City of Torrington

ADDENDUM No. 1

DATE ISSUED: AUGUST 31, 2016

RE: HIGHLAND AVENUE DRAINAGE IMPROVEMENTS (BID # HDI 027-090816)

TYPE "C-L" CATCH BASIN
DETAIL
NTS

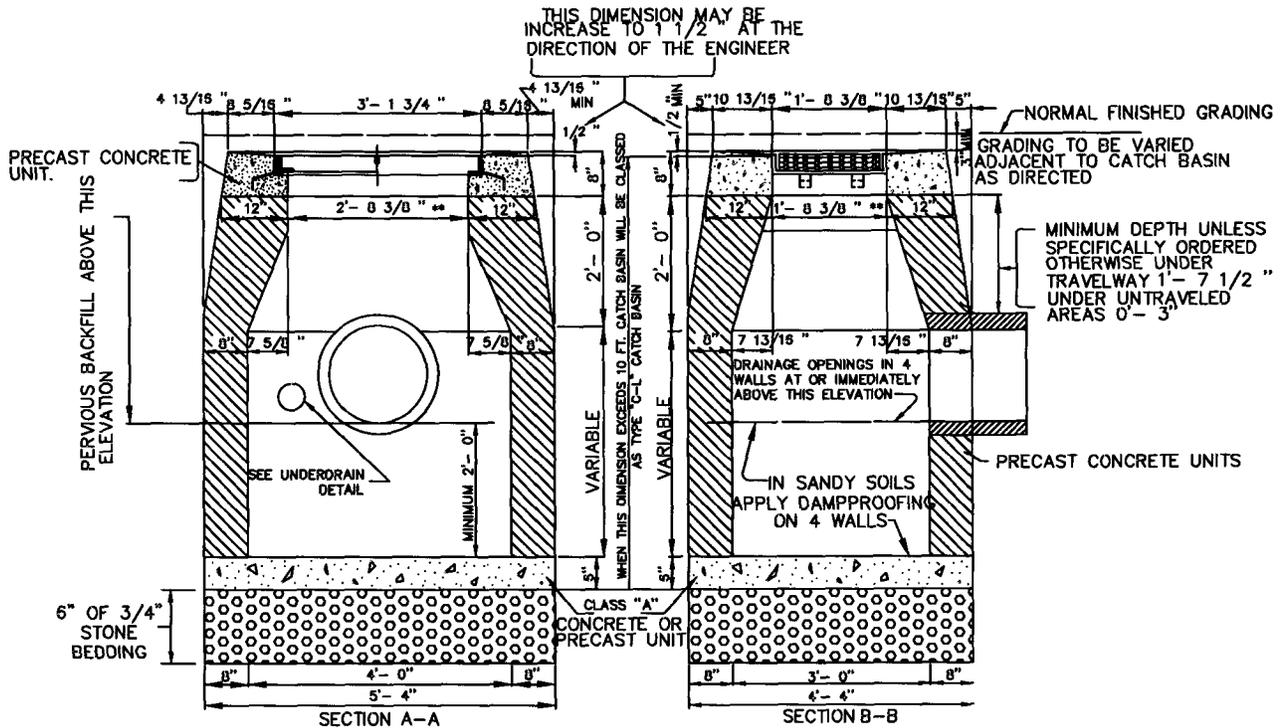
1. **Replace Bid Form – Exhibit “A”** pages C-11A through C-11F with the attached revised Bid Form – Exhibit “A” pages C-11A through C-11F dated 08/31/2016.
2. **Replace Special Provision 01205 Storage and Protection**, page 01205-01 with the attached revised page 01205-01 dated 08/31/2016.
3. **Replace Special Provision 02220 Trenching, Backfilling, and Compacting** pages 02220-01 through 02220-07 with the attached revised pages 02220-01 through 02220-07 dated 08/31/2016.
4. **Replace Special Provision 02500 Storm Drainage** pages 02500-01 through 02500-09 with the attached revised pages 02500-01 through 02500-10 dated 08/31/2016.
5. **Replace Detail 4.1 Type “C-L” Catch Basin Detail on Drawing Sheet 009** with the attached revised **Detail 4.2 Type “C-L” Catch Basin Detail** dated 08/31/2016.

1. WALLS OF ALL CATCH BASIN OVER 10 FT DEEP TO BE INCREASED TO 12" THICKNESS. INSIDE DIMENSIONS TO REMAIN THE SAME.
2. PRECAST CONCRETE TOP SHALL BE APPROVED BY THE ENGINEER BEFORE INSTALLATION.
3. CATCH BASIN SUMPS SHALL BE OMITTED IF DIRECTED BY THE ENGINEER.
4. PROVIDE 4" PVC PERFORATED WEEP PIPE TO RELIEVE THE GROUNDWATER FROM THE PIPE BEDDING. PLACE AT ALL LOCATIONS WHERE PIPE ENTERS OR EXITS THE STRUCTURE.
5. ALL GRATES SHALL BE TYPE "A" GALVANIZED GRATES.
6. CB TOP BE SET ON MIN. OF 2" TO MAX. 4" OF MASONRY FOR ADJ.
